March 11, 2019

Scott D. Portzline
Eric Epstein
Three Mile Island Alert
4100 Hillsdale Road
Harrisburg, PA 17112

SUBJECT: 10 CFR 2.206 Petition on Apparent Violation of 10 CFR 50.9

Exelon's graph¹³ on steam tube deflection + extended extrapolation

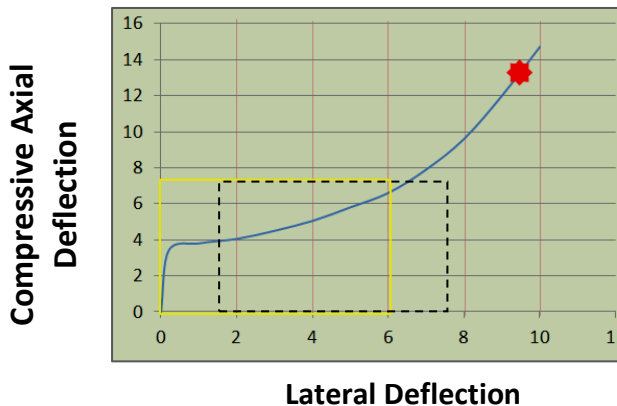
Exelon's original graph is bound by the dotted lines on the lower left. The graph has been extended here by TMI Alert to extrapolate how great the lateral deflection or bowing would be if temperatures rose to 1100°F degrees as marked by the red star. Normal operating temperatures are ~ 550°F. An analysis is needed to determine the accuracy of this projection because the actual value is not known.
